STAFF REPORT

File Number
PDC04-018

Application Type
Planned Development Rezoning

Proposed Use: Community retail center of up to 385,000 square feet

SHEET 2A

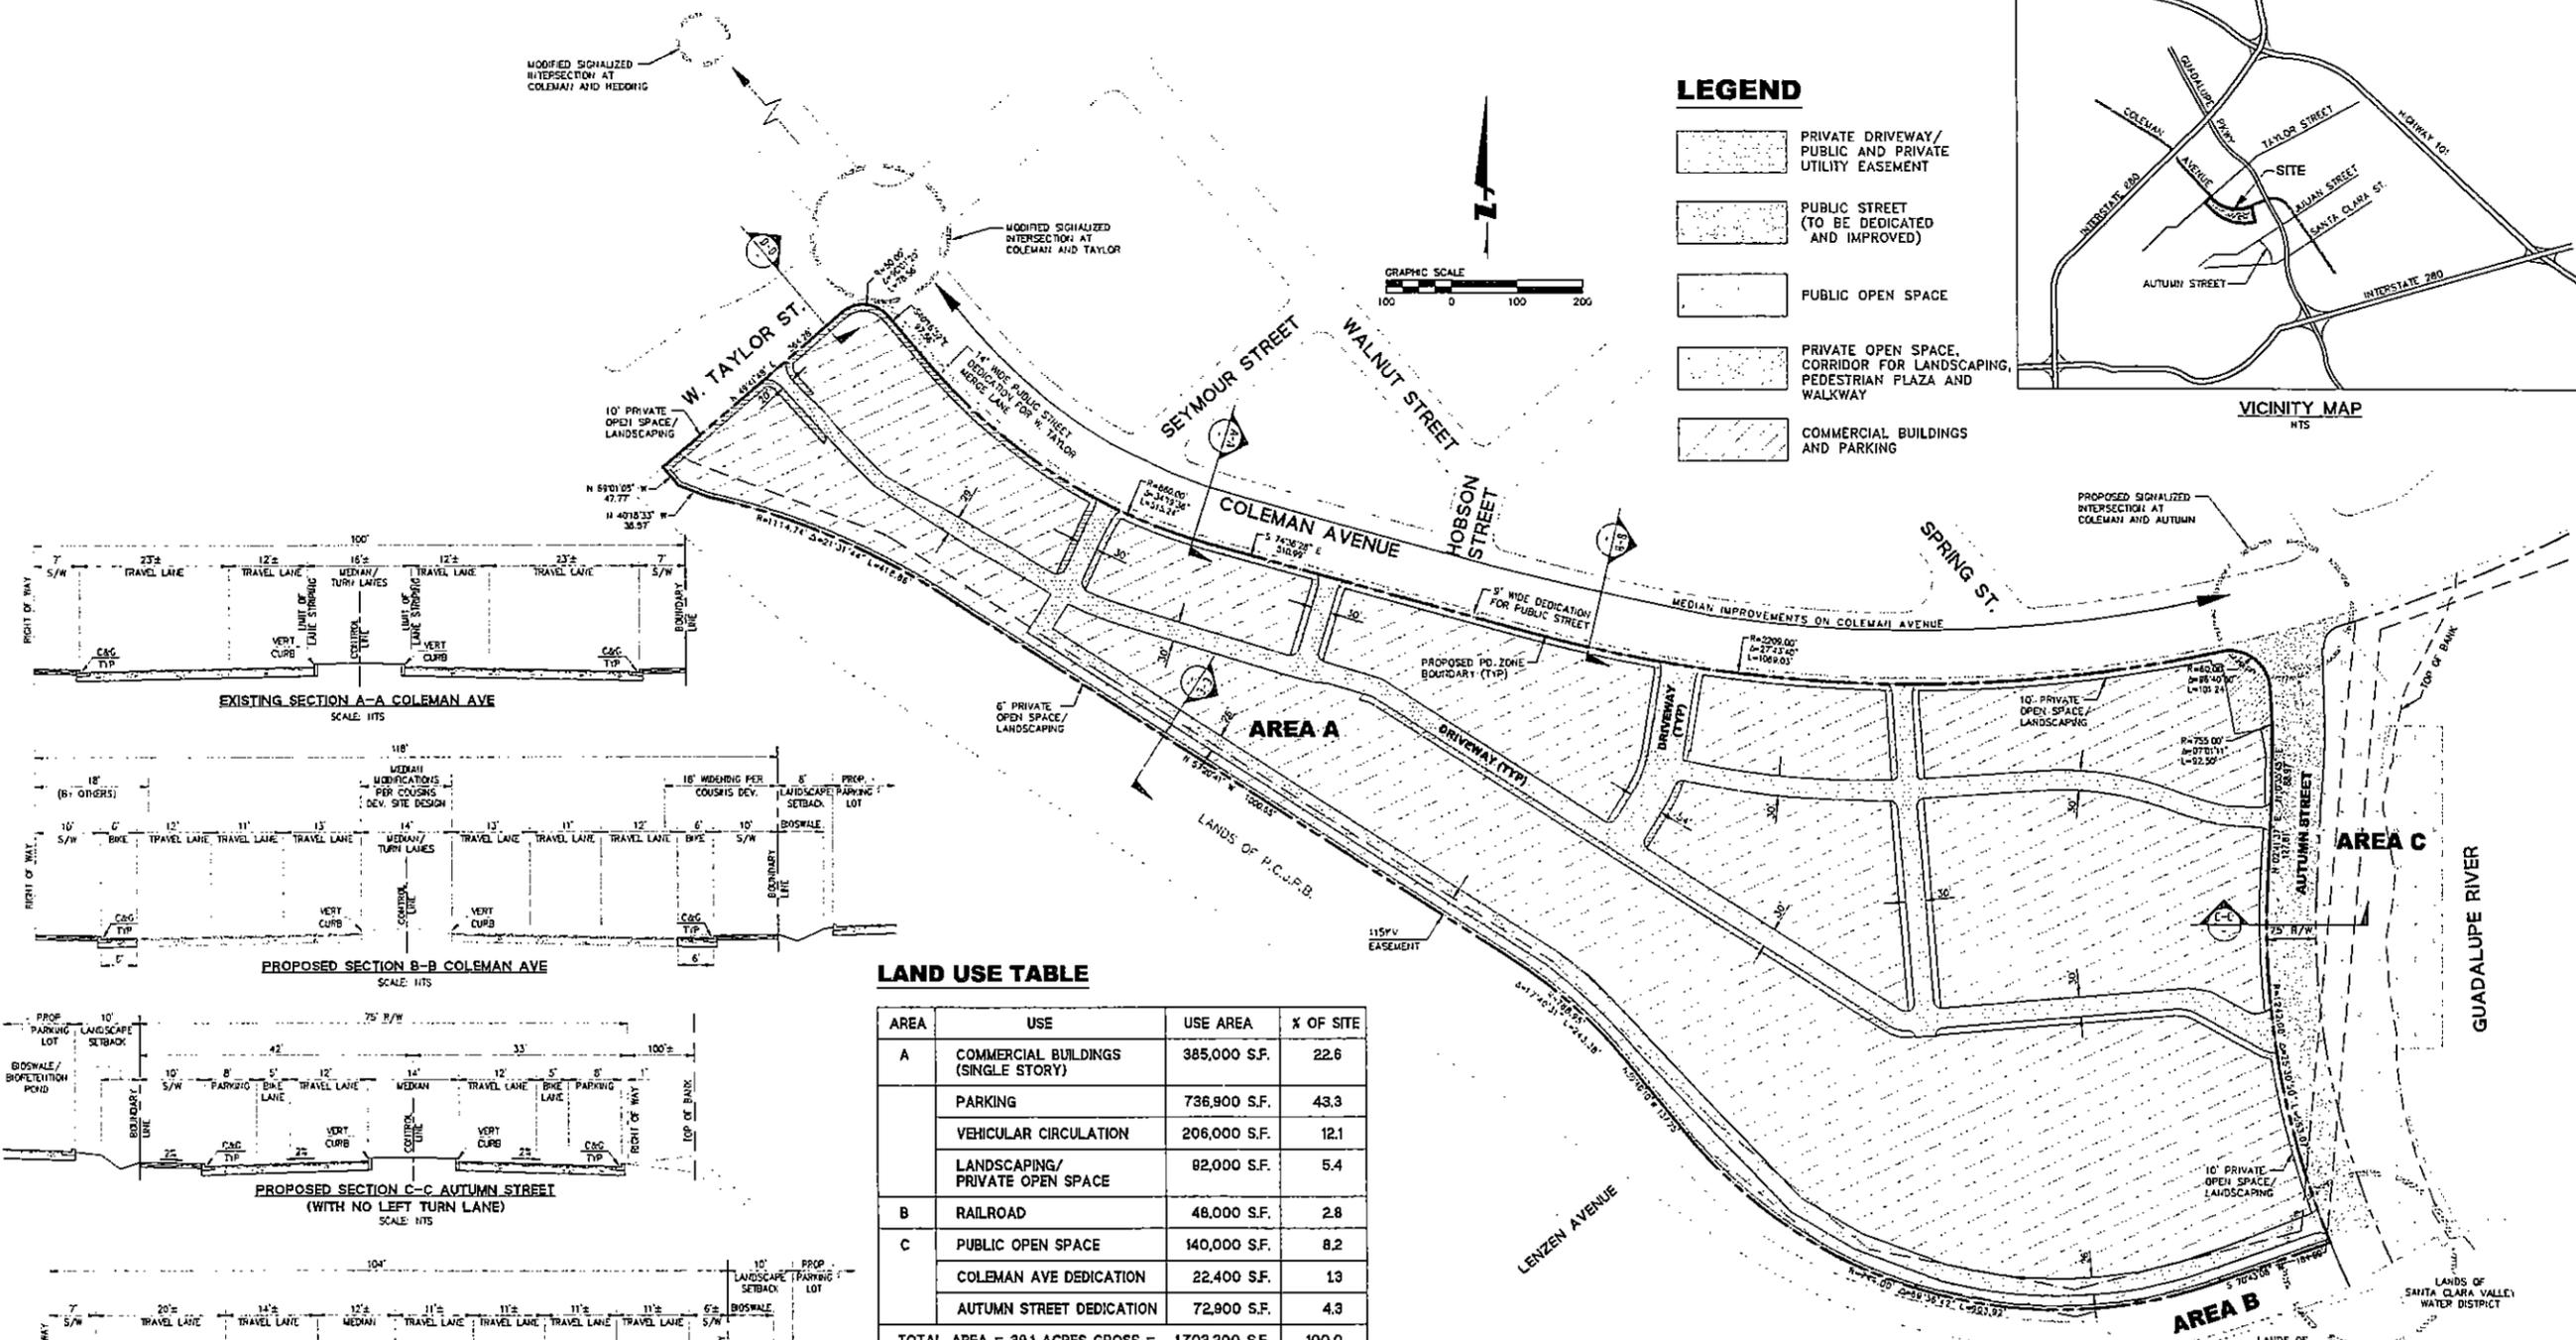
The proposed project includes the construction of a portion of Autumn Street at its new alignment as shown on the *San Jose 2020 General Plan Land Use/Transportation Diagram*. Autumn Street is an Arterial Street (80-106 feet wide) that will be located on the eastern side of the project site from Coleman Avenue to the Union Pacific railroad right-of-way. This new street would be signalized at Coleman Avenue and have one traffic lane, one parking lane and a striped bicycle lane in each direction, and a landscaped median. The eastern edge of this road would be set back 100 feet from the west bank of the Guadalupe River. In addition, the *San Jose 2020 General Plan Land Use/Transportation Diagram* designates Autumn Street to be further extended to Julian Street as properties along the realignment are redeveloped to the south of the project site. (see San Jose Market Center EIR page 34 and plan set sheet 2A).
